October 21, 2008

- SUBJECT:** **2008-0637 - Downtown Sunnyvale Mixed Use, LLC.**
[Applicant/Owner]: Application located at **2502 Town Center Lane** in the DSP-18 (Downtown Specific Plan Block 18) Zoning District. (APN: 209-34-009, 010, 015, 016, 017, 018 and 209-35-001, 005, 007, 010, 011, 012)

REPORT IN BRIEF

PERSPECTIVE OF BRICK WALL CANOPIES

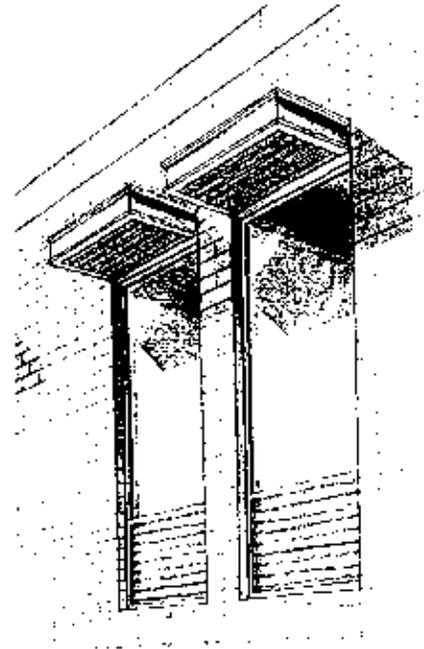
1. Condition A30.9)—New: Work with staff to redesign the brick canopies with a more traditional downtown appearance.
2. Condition A.32.4)—Delete: (repeats condition A.32.2)
3. Condition A.32.6)—New: Redesign the upper level northeast corner of the parking garage to match, or be of a similarly significant design as, the northwest corner of the garage.
